APPROVED MINUTES

September 16, 2021 Standards Committee Meeting

RE: Minutes from the September 16, 2021 Standards Committee Meeting

E 801-TCTC-10 MAINTENANCE OF TRAFFIC FOR RPM REFLECTOR REPLACEMENT (WITH MARKUPS)

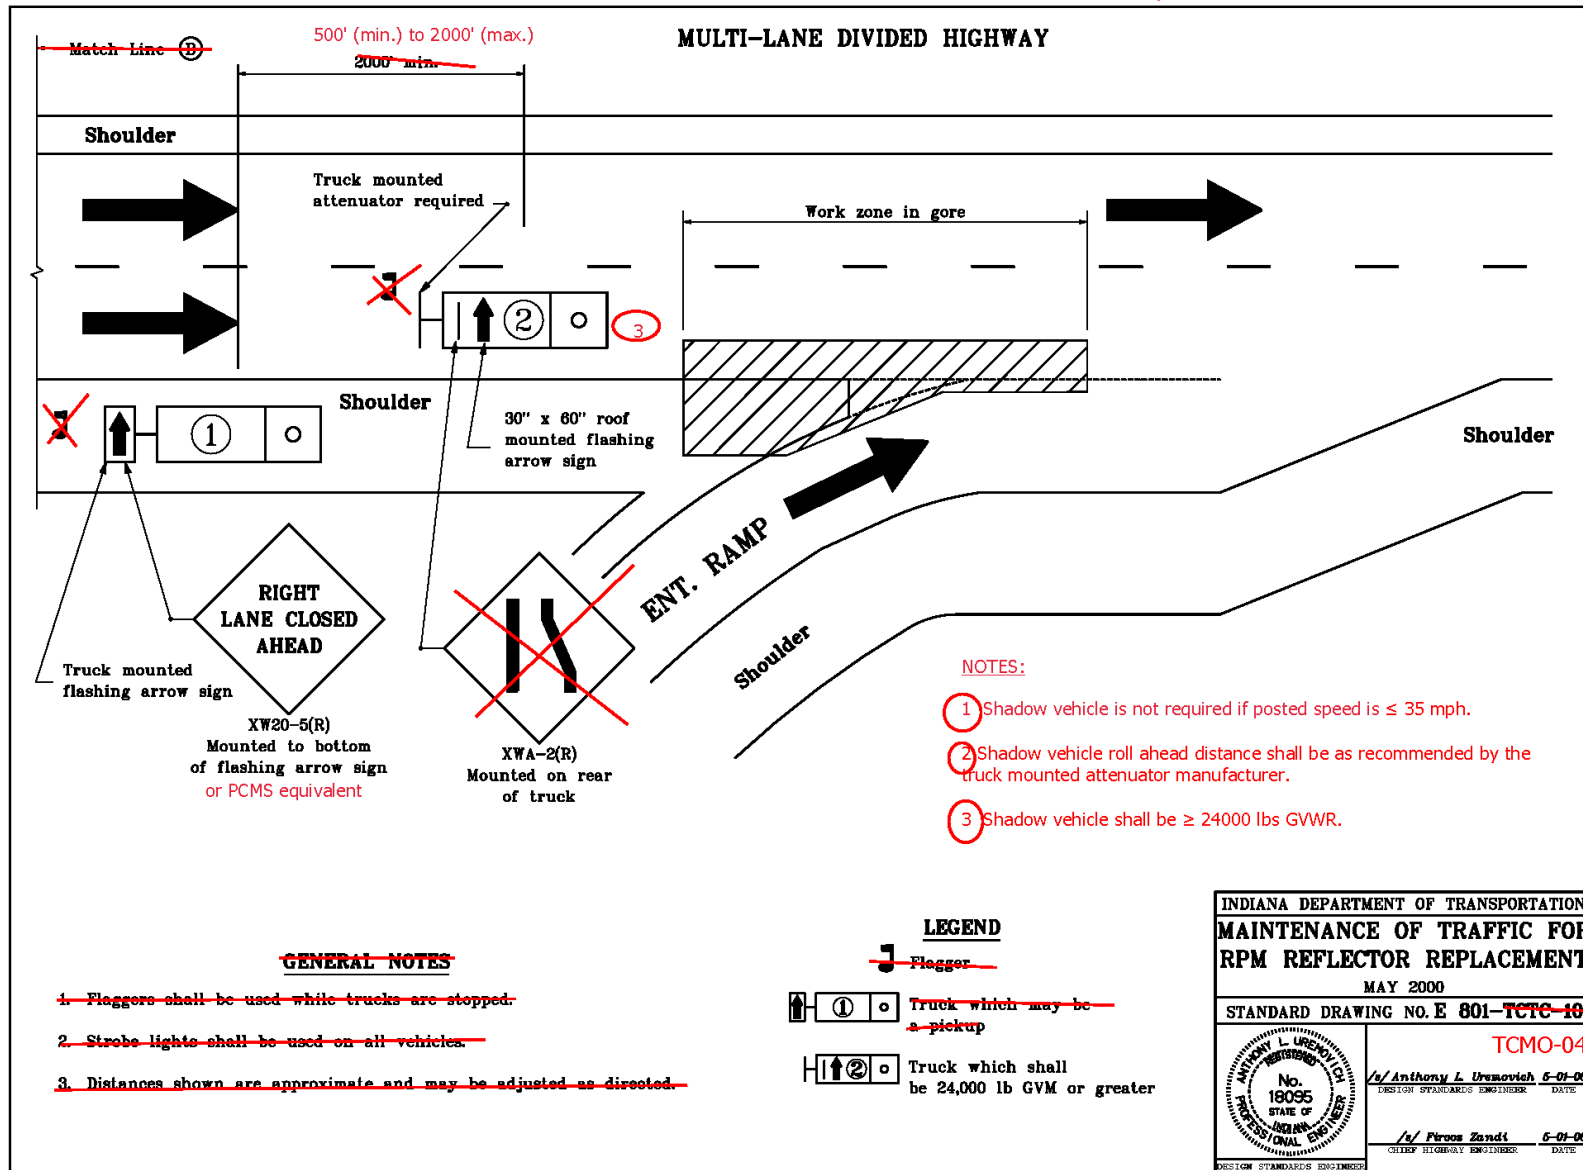
Move to new series on Traffic Control for Mobile Operations
